TECUMSEH

Update 2006

ENGINES & TRANSMISSIONS

FACTORY TRAINING

OV195EA Rod Change

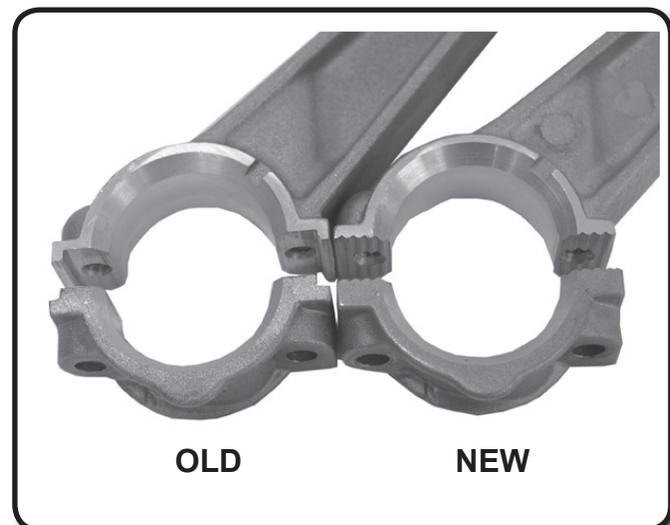
The OV195EA is changing the style of the joint between the connecting rod and rod cap. This was done to standardize the process in machining and assembly for LV and OV195 engines. The OV195 rod will be changing from a stepped joint to a serrated joint. Always remember that it is critical that the match marks on the rod and cap must face each other and face out toward the technician when they are assembled. The torque spec on the OV195 rod for both the stepped joint and the serrated will remain at 50-60 in. lbs. (5 - 6 Nm).

New Governor Shaft, Linkage & Cylinder Cover

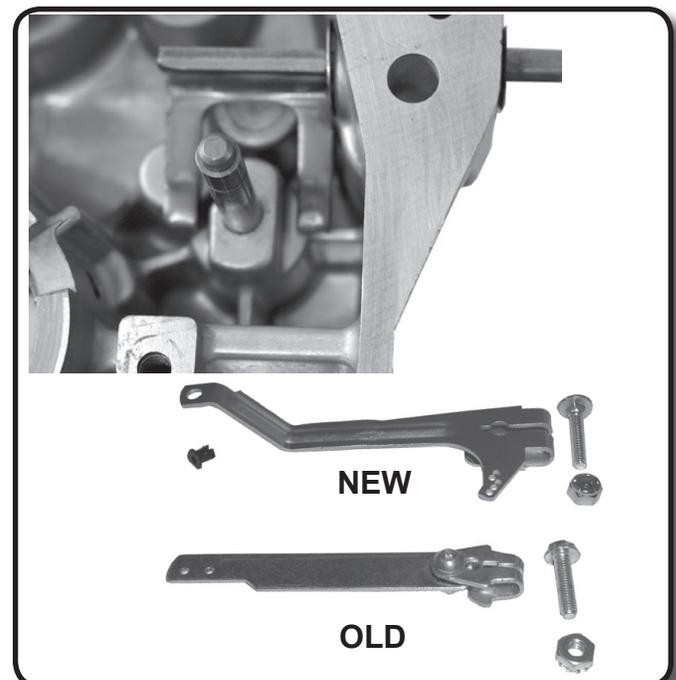
The LH318, LH358 & OH318 will have a newly designed yoke style governor system. This design rests evenly on both sides of the governor spool and provides quick governor response and a more consistent speed control. A new one piece governor lever has also been incorporated simplifying the adjustment procedure. This eliminates the smaller lever section that attached directly to the governor shaft. The cylinder cover crankshaft bearing area has been beefed up to give added support and strength to the entire cover.

Twin Muffler Kit 730660 & 730661 Added Support

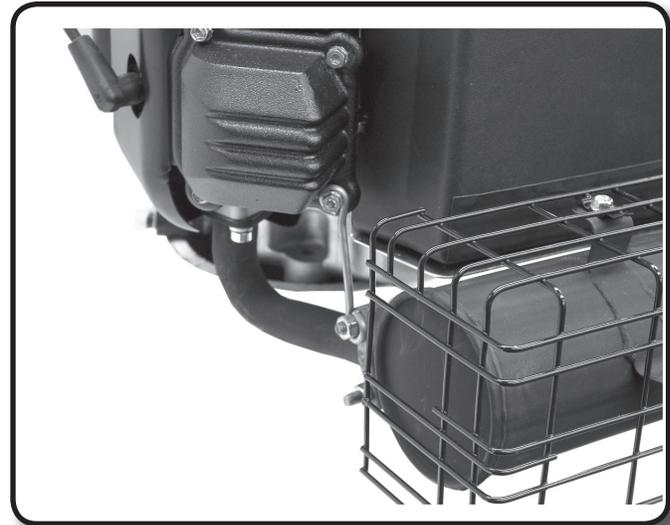
There will be two wire support brackets added to these horizontal muffler kits for twin cylinder engines. These brackets will go from the lower insider rocker box bolt to the muffler clamp on the crossover pipe. These brackets have been added to give the muffler greater support and stability.

OH318SA Baffle

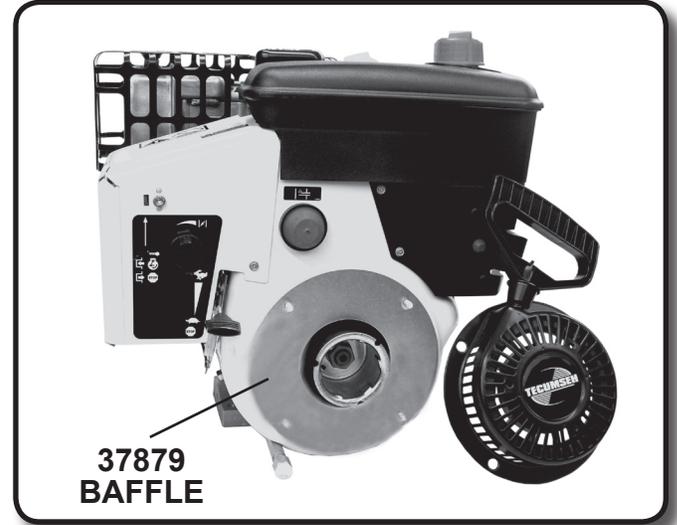
A baffle is being added to the OH318SA Snow King engine to prevent the potential for freeze ups to occur in the carburetor. This baffle part number **37879** helps the heater box generate sufficient heat to warm the air around the carburetor to prevent moisture from accumulating and freezing. The restrictor baffle is placed between the recoil and the blower housing. The kit will retrofit on existing OH318SA's, but should only be used where there has been a persistent icing problem. This information can also be found on **Service Bulletin 129**.

TM049 Recoil Change

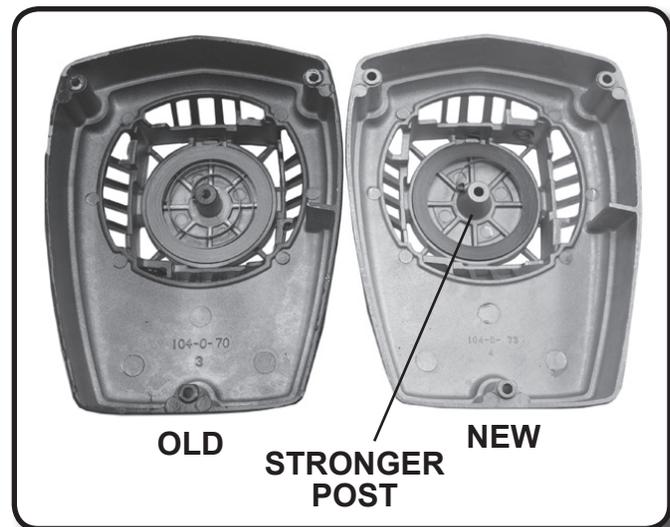
In our quest for product improvement, we have increased the dimension of the center post on the TM049 recoil housing. These changes have made it necessary to also change the components which make up the assembly. The pulley has been changed to accommodate the increased size on the housing post. This dimension change will occur at the bottom of the pulley and will not affect the fit on any existing housings. However, when a new style pulley is used it will require a new recoil spring be used. The new spring is thinner and will allow the recoil rope to extend fully when the rope is pulled. Remember it will now be necessary to replace both components for the recoil to operate properly.

TM049 Starter Dog Change

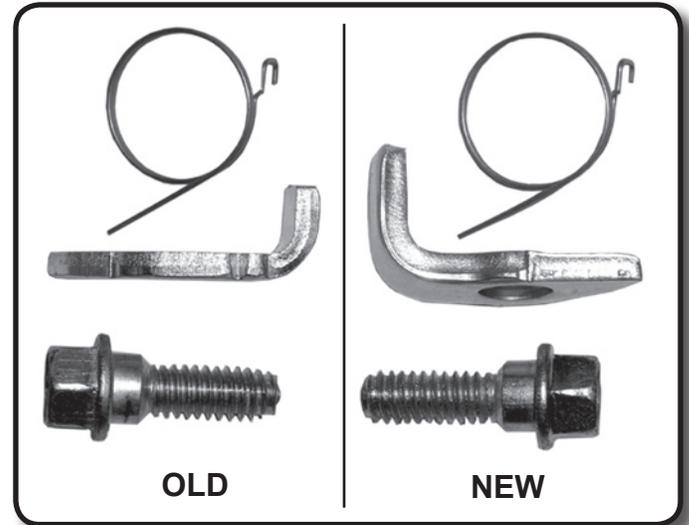
The spring loaded starter dogs used on the TM049 have been changed to give some additional strength to help increase cold weather durability. These parts have been thickened which means the space on the tang of the spring had to be widened and the depth on the shoulder of the screw changed to accommodate for that upgrade. These parts will only be sold as a kit (part number **590779**) and will supersede any of the individual component parts from the original spec. The kit will retro fit any existing flywheel that uses these components. Included in the kit are, pawl springs, starter pawls, shoulder screws, recoil spring, starter pulley, washer and two of each, 10-24 x 1-3/8" screws and 10-24 x 13/16" screws.

Piston Wrist Pin Circlip

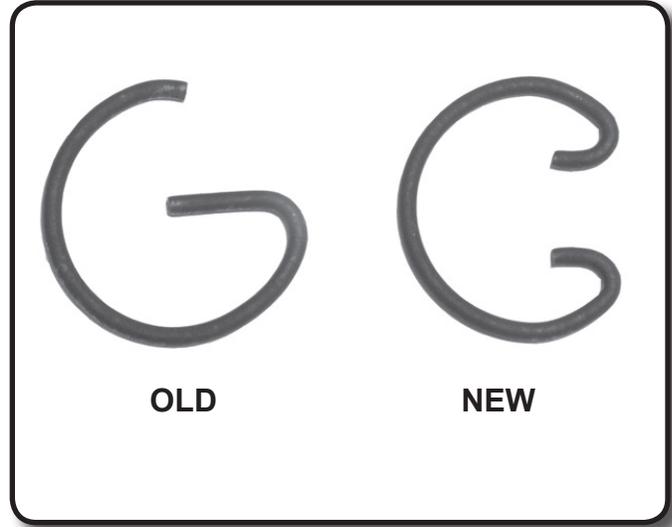
The wrist pin circlip on the TV085, TH098 and TH139 is being changed from a "G" shape to a "U" shape design. The "U" shaped clip will make it much easier to remove and install the circlip into the piston wrist pin area when servicing the engine. This will reduce the possibility of scratching the piston skirt and causing damage to the cylinder bore.

Series "14" Single Carbureted Twin

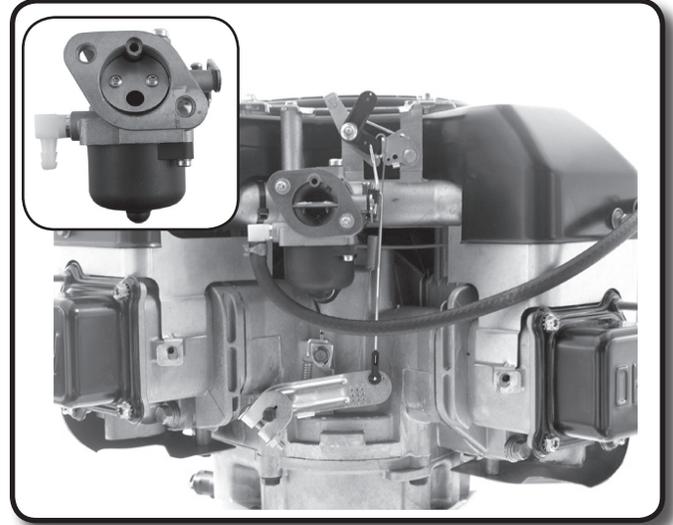
The series 14 carburetor will be available this year on some of the OV691 engine's as an option. On those selected models this single carburetor feature will be used in place of the proven dual, series "7". It is configured as a horizontal choke and throttle plate operation with an easily serviced composite fuel bowl. None of the critical adjustments such as static governor setting or RPM adjustments have changed, so service is simple.

Composite Float Dampening Spring

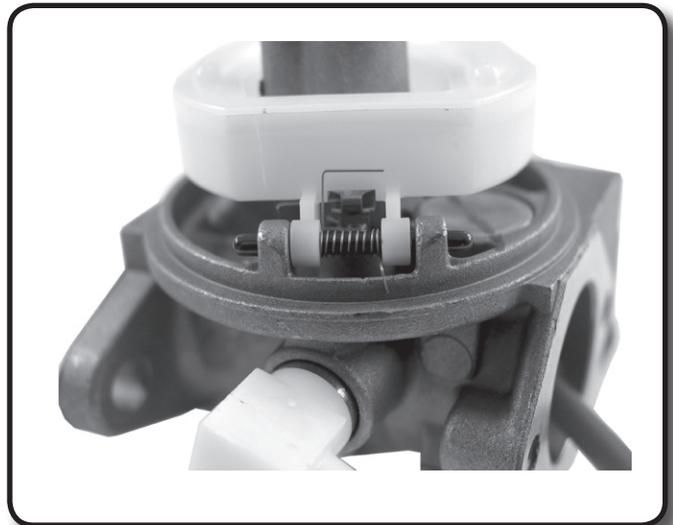
The original design of the composite float prevented the use of a dampening spring. There is a new composite float that will accommodate a dampening spring for those applications that need additional float stability. The float and spring assembly comes in a kit part number **632019A**. If individual part numbers are needed for repair or replacement use the number **632815** for the dampening spring and **632816** for the float. The kit or individual parts will retro fit any application that currently has a composite or brass float.

LTH Mechanical Disconnect Change

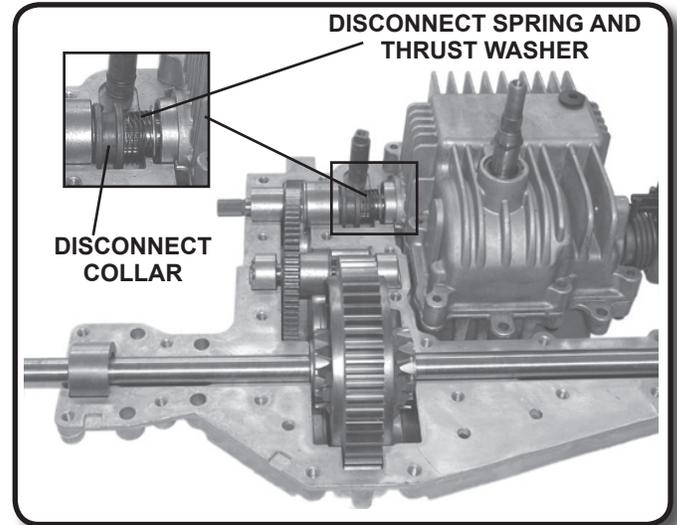
There has been a modification in the spring used on the mechanical disconnect mechanism of the LTH hydrostatic transaxle. The spring rate has been increased to prevent any units from forcing the connect collar off the drive shaft and disengaging the drive. These incidents occurred only occasionally under extreme conditions. Our warehouse stock has been purged and a running change was made in production. If you experience repeated incidents replace the spring. **Service Bulletin 309** outlines the procedure and tools required to make this repair.

SERVICE
BULLETIN
129
INFORMATIONAL

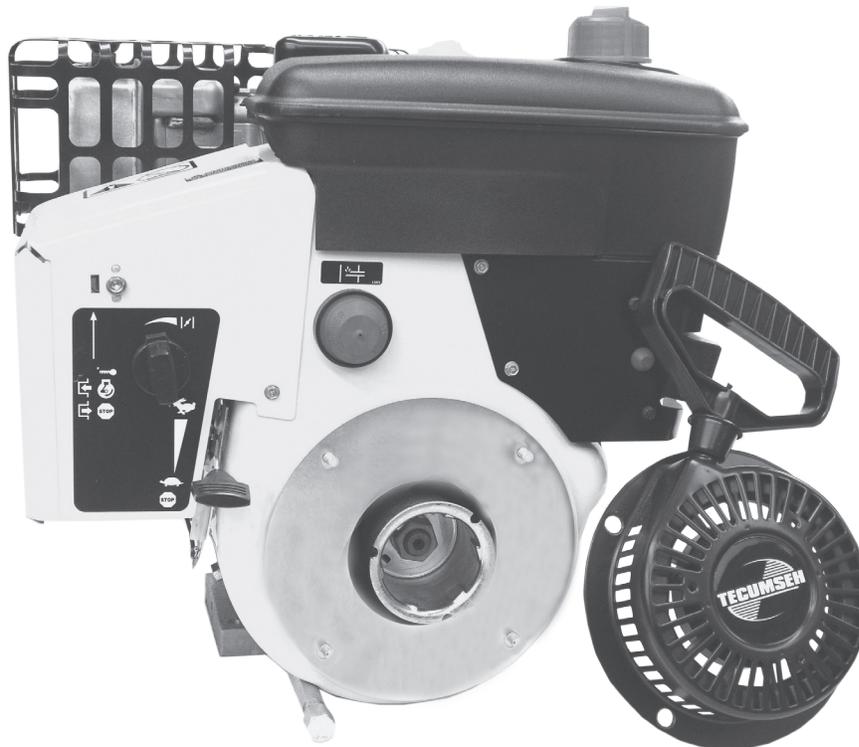
We have received reports from our service network that under certain weather conditions the OH318SA Snow King engine can experience carburetor icing.

Our engineering department has been able to duplicate the symptoms during field tests, and have designed an Air Restrictor Baffle to prevent this from occurring. The restrictor baffle (**part number 37879**) was designed to help the heater box generate sufficient heat to warm the air around the carburetor preventing moisture from accumulating and freezing.

The restrictor baffle is placed between the recoil starter and the blower housing. The kit will retrofit existing OH318SA's, but should only be used where there has been a persistent icing problem.

Simply remove the recoil assembly from the engine, place the air restrictor plate over the recoil-mounting studs. Install the recoil assembly onto the blower housing of the engine and torque the nuts to 80 inch lbs. (9Nm).

SERVICE
BULLETIN
130
INFORMATIONAL

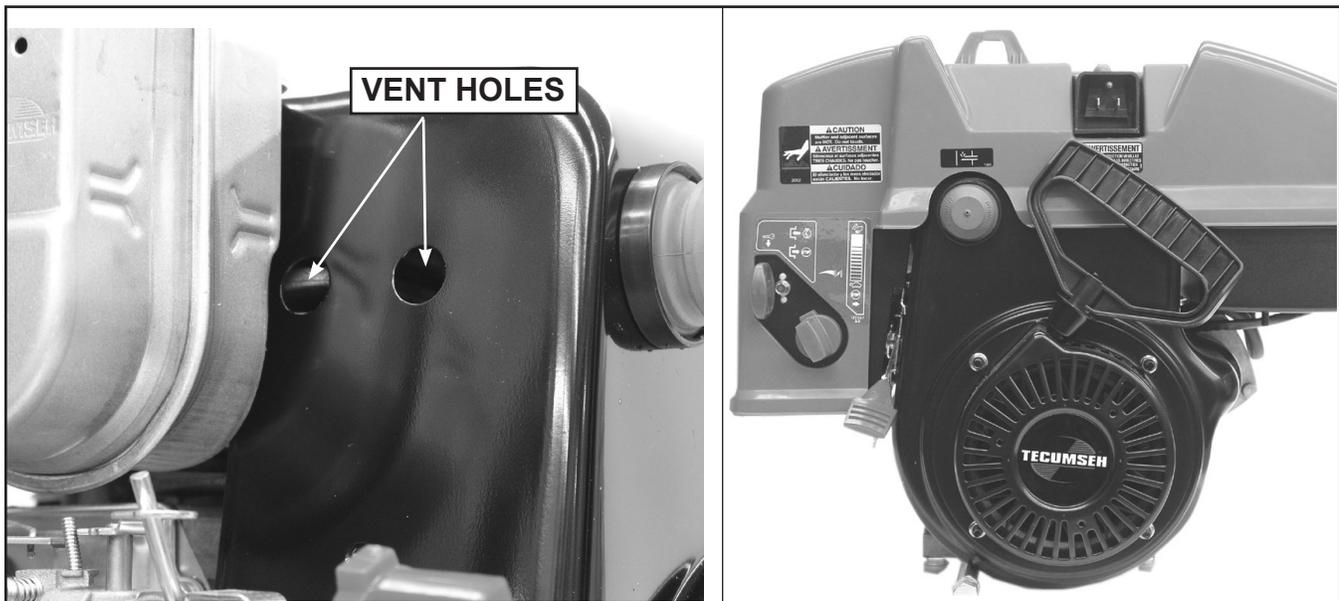
We have identified a concern with poor run quality under no load on the 2004/2005 stylized LH318/358SA (Snow King) engines. Testing by our engineering department has confirmed that increased carburetor air intake temperatures can occur with the use of some regional blends of fuel.

If a unit with this additional stylized shrouding is brought in for service exhibiting the symptoms of fuel starvation, (after the engine has reached full operating temperature) the condition may be resolved by changing the blower housing.

The new blower housing (**part number 37961**) has two vent holes added to the area just inside the heater box, which reduce the carburetor air intake temperatures.

SERVICE
BULLETIN
131
INFORMATIONAL

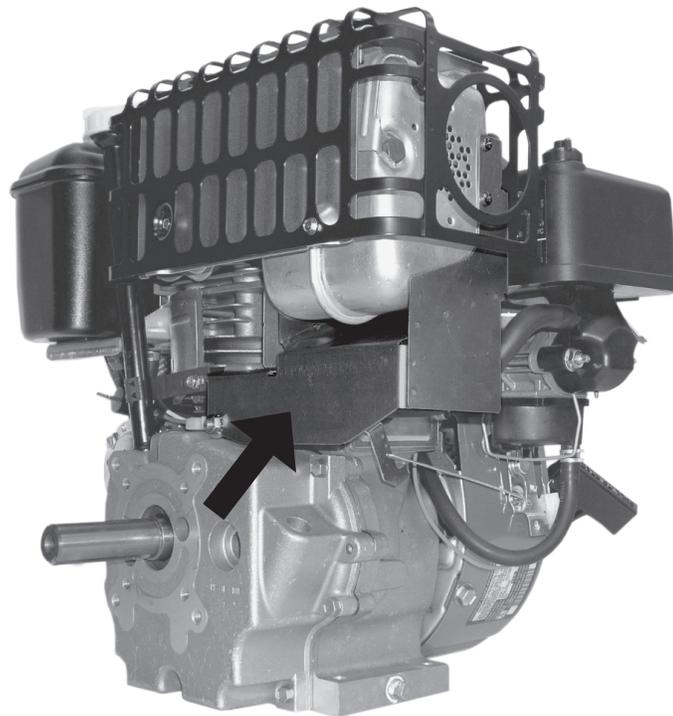
We have received field reports of carburetor icing on the OHM90 & OH318EA (Non-Snow King) engines equipped on Ariens power brush equipment. This occurrence has only been duplicated under conditions of high humidity and a temperature of below 40° F (4° C).

To alleviate this concern a new heater box has been designed, (**part number 730273**) which directs warmer air from under the muffler straight into the air cleaner intake snorkel when the air cleaner cover is in the winter position. The air cleaner cover position must still be changed for operation based on ambient temperatures. This new heater box only needs to be installed on units, which have exhibited this concern.
